ADDENDUM NO. 2

Reference: New Tooele Applied Technology College
Utah College of Applied Technology – Tooele, Utah
DFCM Project No. 11064280

ADDENDUM NO. 2
February 10th, 2012

Tooele Applied Technology College New Building
Tooele, Utah

1 LEVEL 1 LIGHTING PLAN - AREA '2'
SCALE: 1/8" = 1'-0"

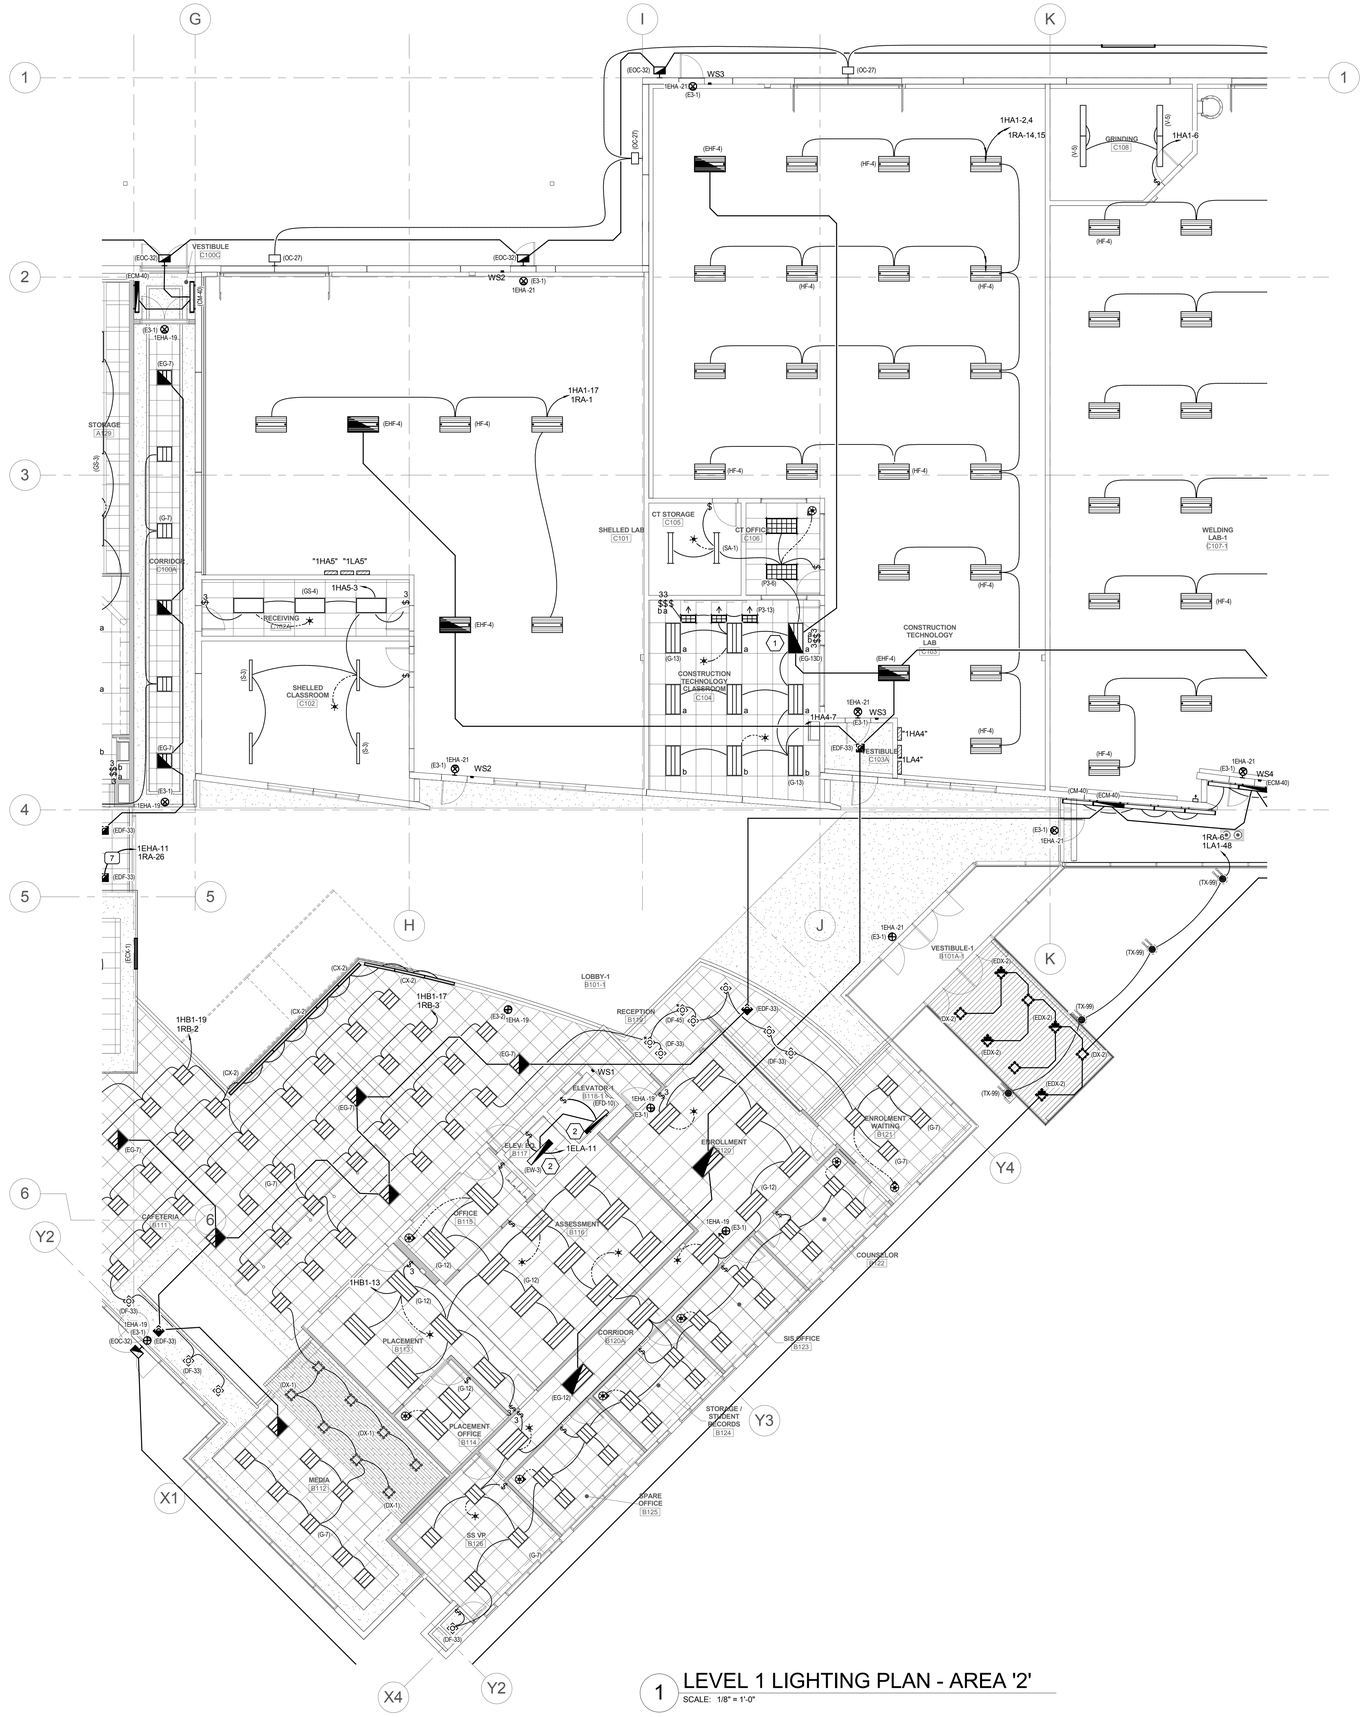
1. Lighting and circuiting has been updated on whole sheet. Refer to attached drawing EL112.

1 LEVEL 1 LIGHTING PLAN - AREA '3'

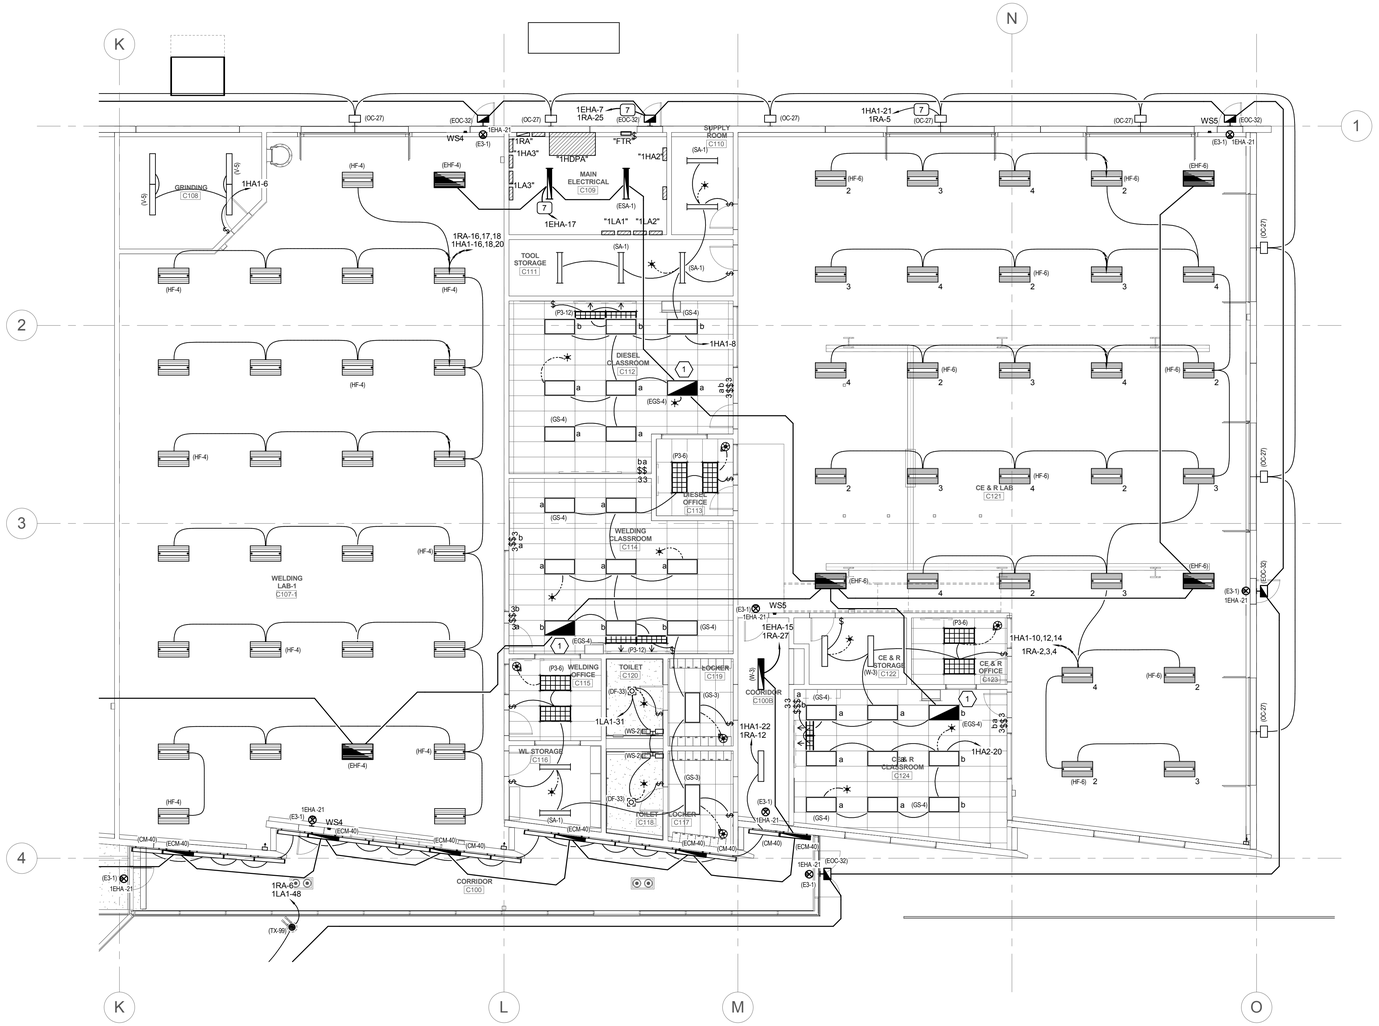
1. Lighting and circuiting has been updated on whole sheet. Refer to attached drawing EL113.

1 LEVEL 2 LIGHTING PLAN - AREA '1'

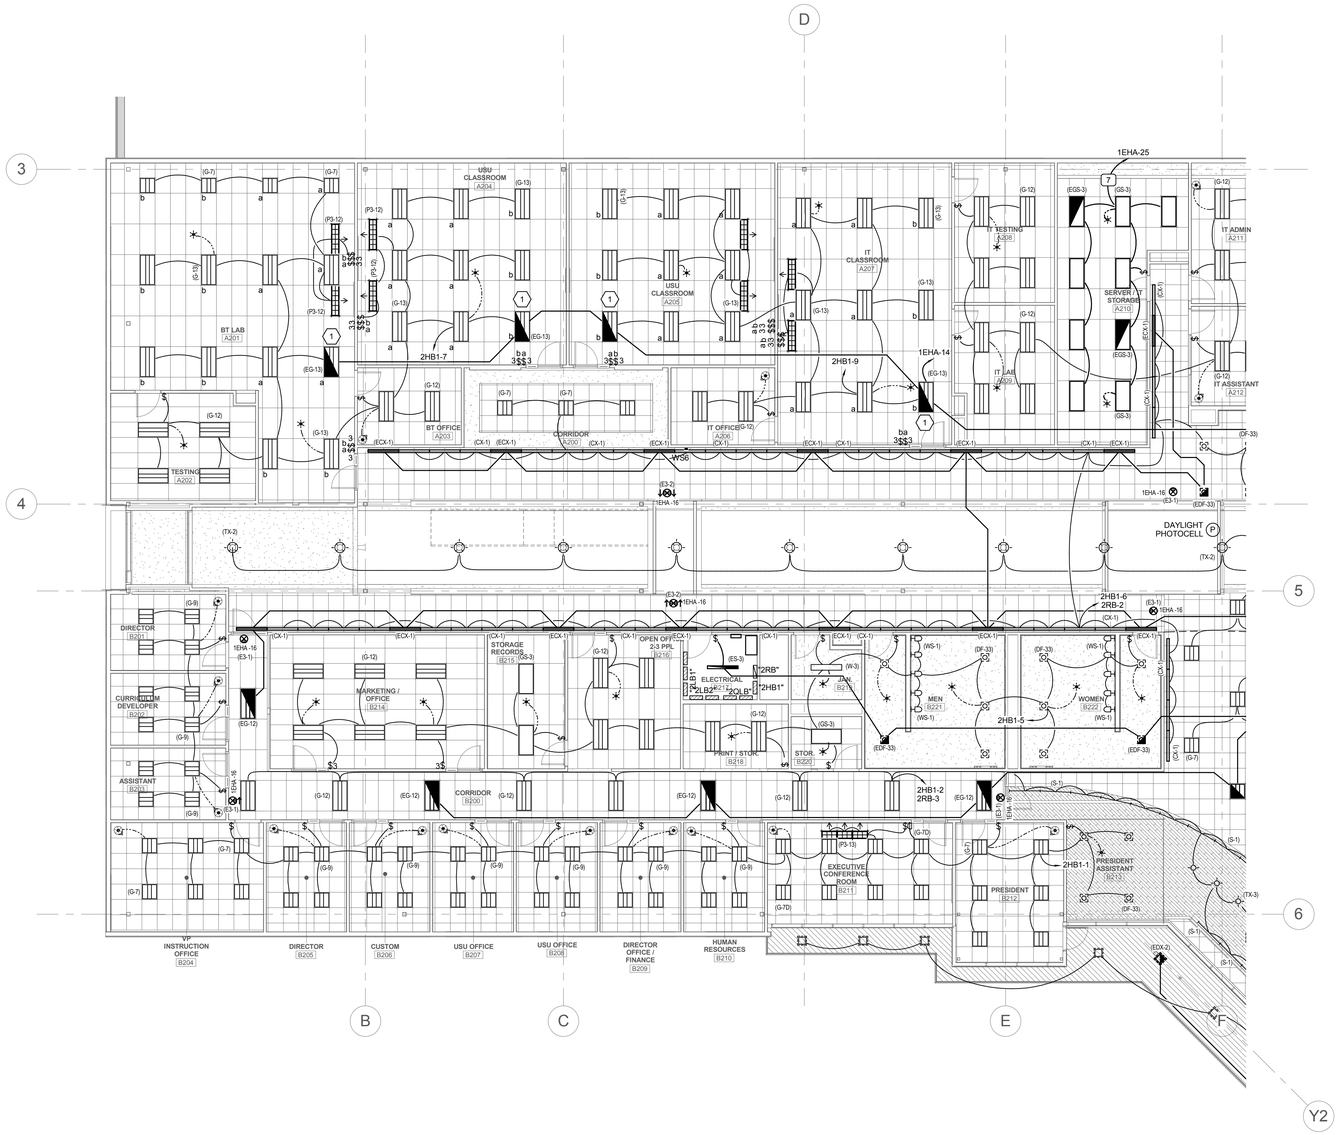
1. Lighting and circuiting has been updated on whole sheet. Refer to attached drawing EL121.

1 LEVEL 2 LIGHTING PLAN - AREA '2'

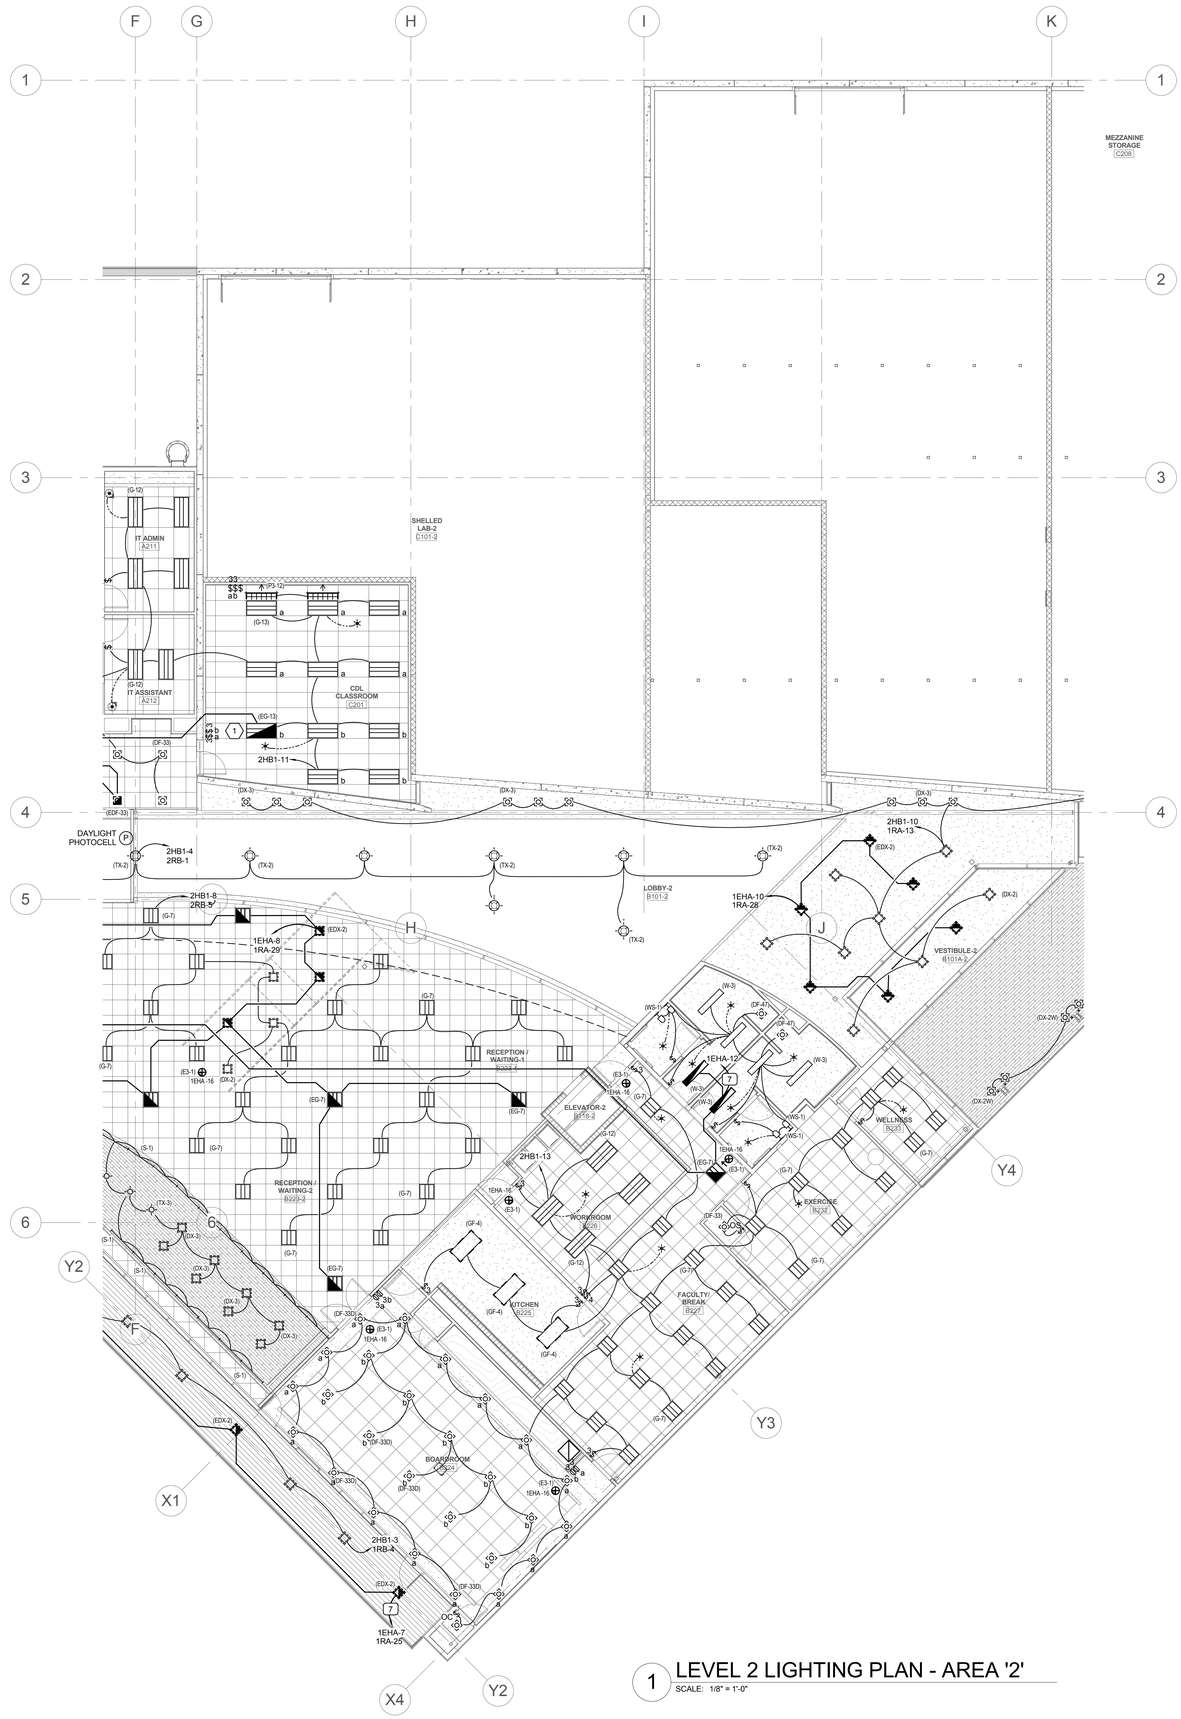
1. Lighting and circuiting has been updated on whole sheet. Refer to attached drawing EL122.

1 LEVEL 2 LIGHTING PLAN - AREA '3'

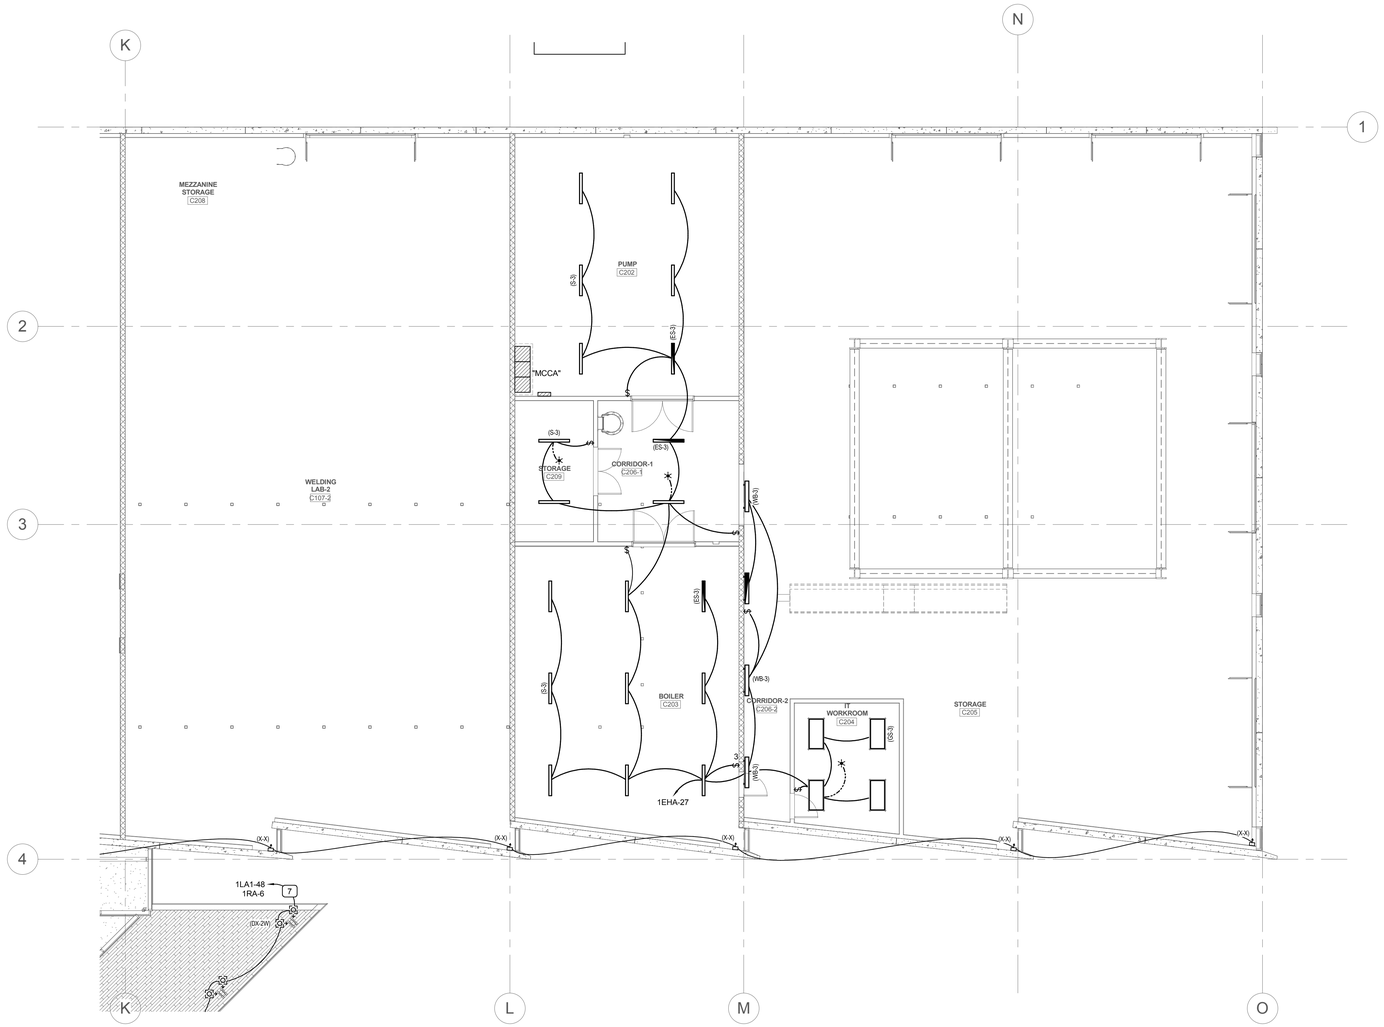
1. Lighting and circuiting has been updated on whole sheet. Refer to attached drawing EL123.

1 LEVEL 1 AUDIO-VIDEO PLAN - AREA '1'

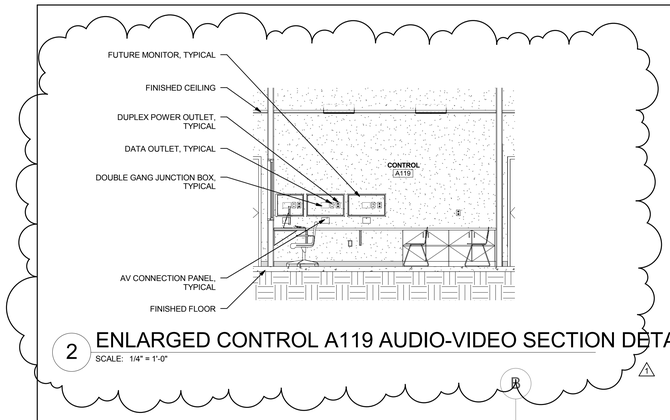
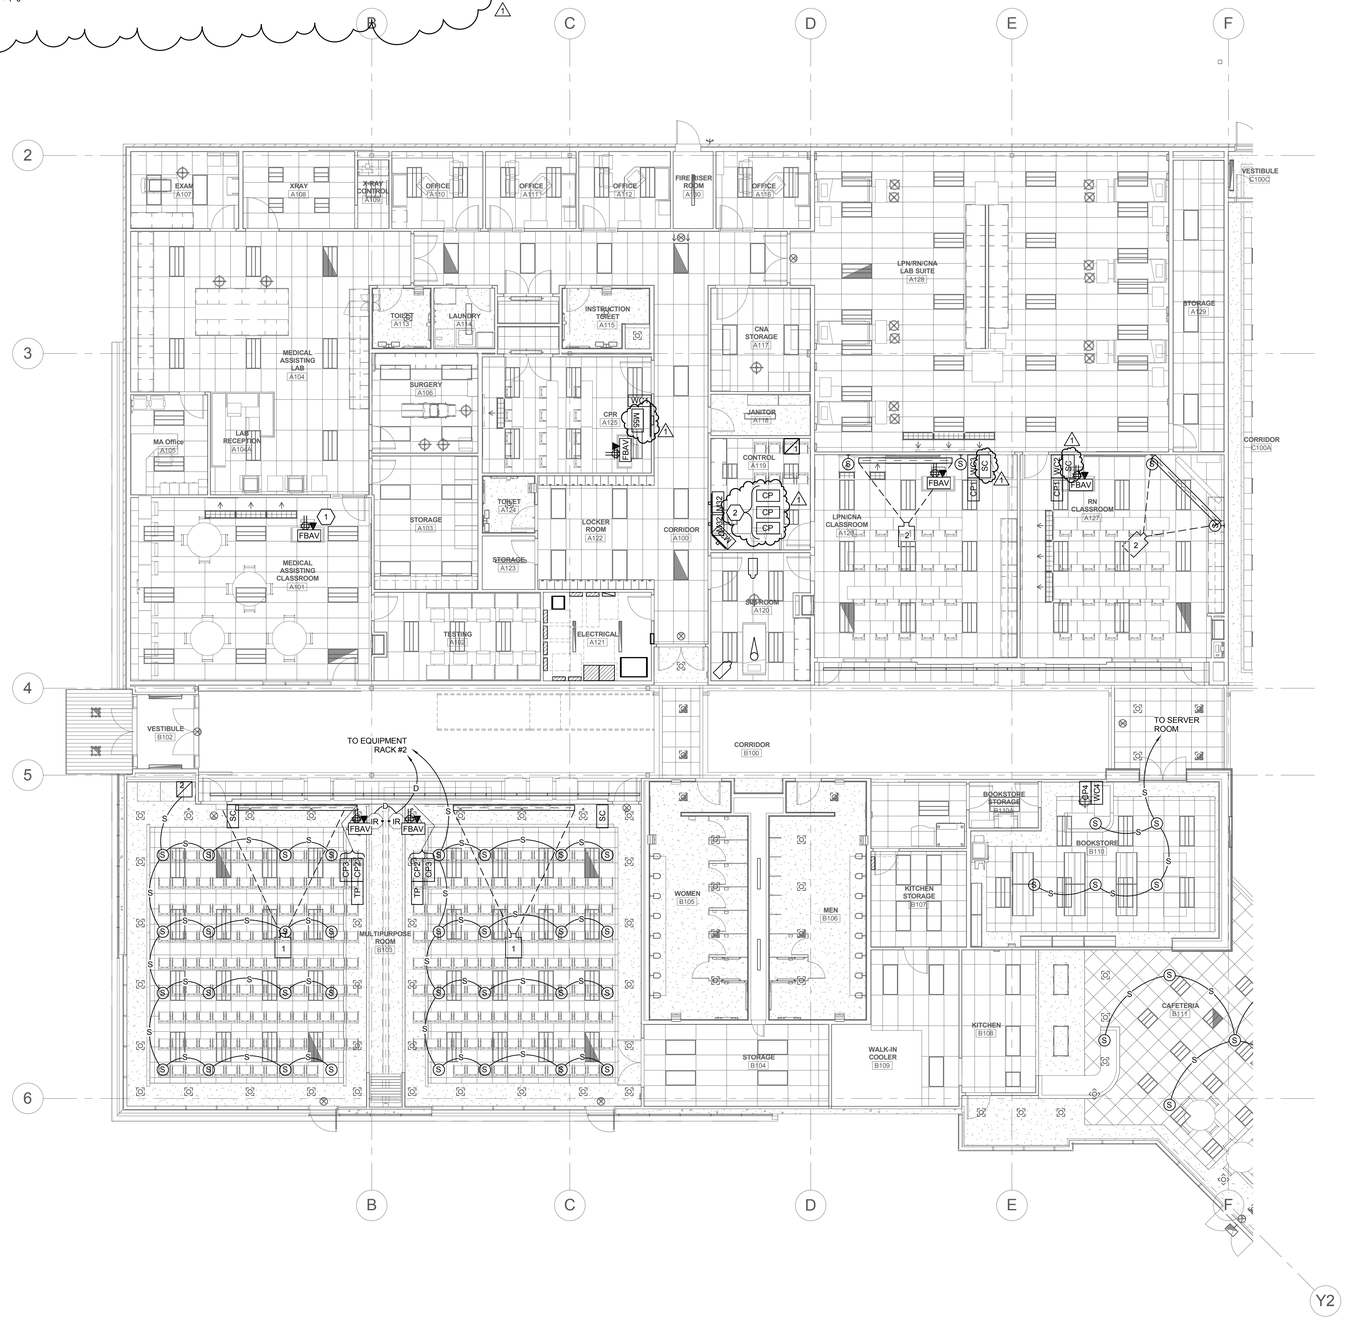
1. Update rough in per the added detail for the Control Room. See attached sheet EJ111.
2. Add Screen control switch in A126 and A127.
3. Updated Screen Size in A125.
